Staff Technical Position on Regulatory Considerations in the Design and Construction of the Exploratory Shaft Facility

U.S. Nuclear Regulatory Commission

Staff Technical Position on Regulatory Considerations in the Design and Construction of the Exploratory Shaft Facility

Manuscript Completed: April 1991
Date Published: July 1991

FIGURE 1 -- An example of an acceptable approach to achieve compliance of the ESF design with 10 CFR Part 60 requirements. Refer to the text in Section 4.0 (Technical Position No. 1) for a discussion of this approach.

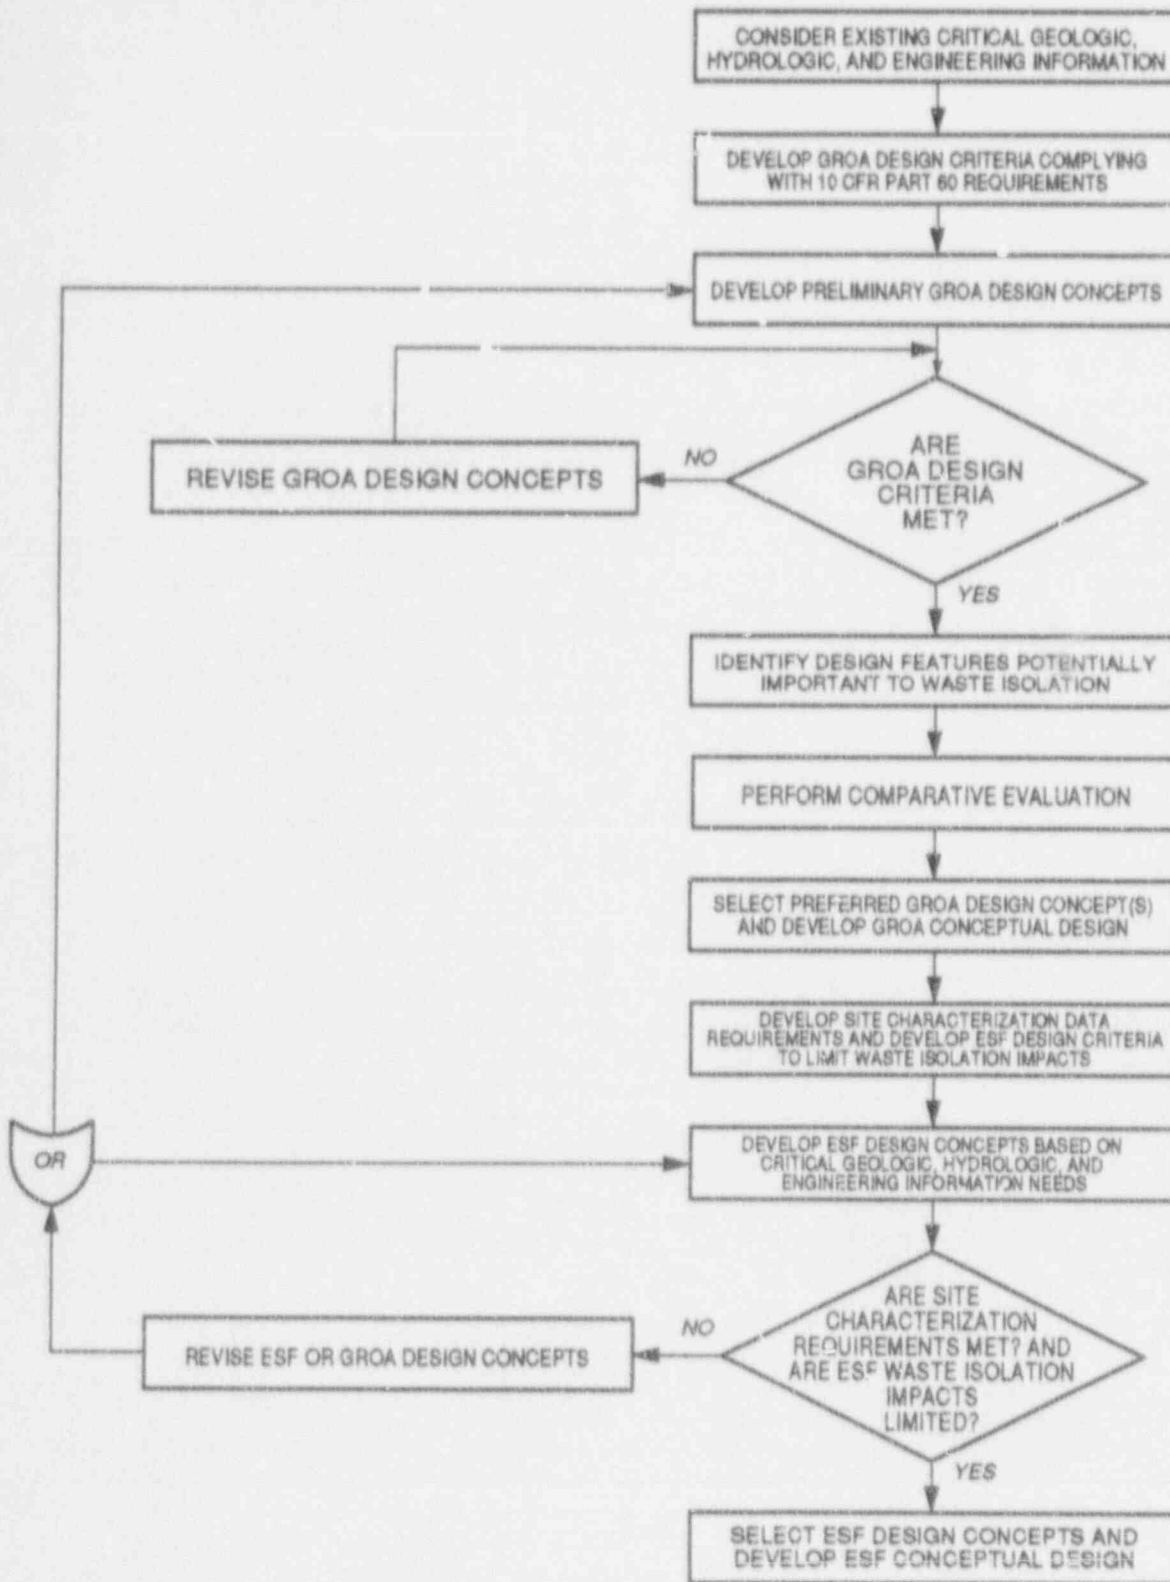
Figure 1 of the TP also introduces the concept of "minimizing" waste isolation impacts, which we believe is beyond the intent of the regulations. 10 CFR 60.15(c)(1) indicates that such impacts should be limited "to the extent practical," which implies that they be acceptable. The revised Figure 1 [Figure D1] also provides recommended changes to this.

This statement, as well as Figure 1, implies that a GROA conceptual design has not yet been developed by DOE. In fact, the SCP includes a GROA conceptual design as required by the NWPA and 10 CFR 60.17(c). See SCP, Vol. VI, Figure 1 provides a graphic confirmation of the inverted priority assigned by the TP to the purpose of the ESF by totally subordinating it to the GROA design. A more fundamental problem with Figure 1 is that it assumes the necessity for compliance of the ESF design with 10 CFR Part 60, when there is no basis for such an assumption.

comment that Figure 1 of the draft STP implies that a GROA conceptual design has not been developed by DOE.

Several other revisions suggested during our discussions with the NMSS staff include removal of wording in the STP that could be considered as adversarial, modification of the flow chart presented in Figure 1, and expansion of Item (7) (Establishment of Ranges of Site Parameters) [in Section 3.0].

Why doesn't Figure 1 reflect the statement in the STP that "In reality, we recognize that both efforts (ESF and repository (i.e., GROA) design) may well proceed simultaneously ..., " et cetera.

The staff agrees with the comment that the waste isolation impacts should be limited "to the extent practical" and they need not be minimized. However, should a design feature be acceptable and, based on existing information, an alternative to this feature is known to have significant advantages, the alternative design feature should not be dismissed merely because the original design feature was acceptable. In this context, the staff has revised the phrase in the process block in Figure 1 reading "Develop ESF Design Criteria to Minimize Waste Isolation Impacts" with the phrase "...Develop ESF Design Criteria to Limit Waste Isolation Impacts."

Also, in the same figure, the process block reading "ESF Waste Isolation Impacts Minimized and Site Characterization Requirements Met?" now reads "Are Site Characterization Requirements Met? and Are ESF Waste Isolation Impacts Limited?" The discussion (in Section 4.0) behind Technical Position No. 1, has been revised accordingly, to track with these changes.

As regards the ACNW's comments on the modification of the flow chart presented in Figure 1, the staff has modified the figure and the text in Item (1) of Section 4.0, accordingly. Four ACNW-recommended changes were made to Figure 1: (1) The addition of a new process block entitled "Consider Existing Critical Geologic, Hydrologic, and Engineering Information" at the beginning of the example approach; (2) changing of the title of the process block entitled "Develop ESF Design Concepts" to "Develop ESF Design Concepts Based on Critical Geologic, Hydrologic, and Engineering Information Needs"; (3) the connection of the two process blocks entitled "Revise ESF or GROA Design Concepts" and "Develop Preliminary GROA Design Concepts" by an activity line (through an "Or" gate); and (4) the shifting of an activity line from the "Revise ESF or GROA Design Concepts" process block to a new position (through an "Or" gate) as input to the process block entitled "Develop ESF Design Concepts" from an original position that was between "Develop ESF Design Concepts" process block and the decision block entitled, "Are Site Characterization Requirements Met? and Are ESF Waste Isolation Impacts Limited?"

This comment is noted. The staff considers that although it is possible to proceed with the design of the ESF and the GROA simultaneously, this approach is not likely to be used. Therefore, Figure 1 does not reflect this approach. However, the approach shown in Figure 1 is only one of the acceptable ways DOE can proceed with the ESF design process. It does not preclude DOE from using other possible acceptable approaches.
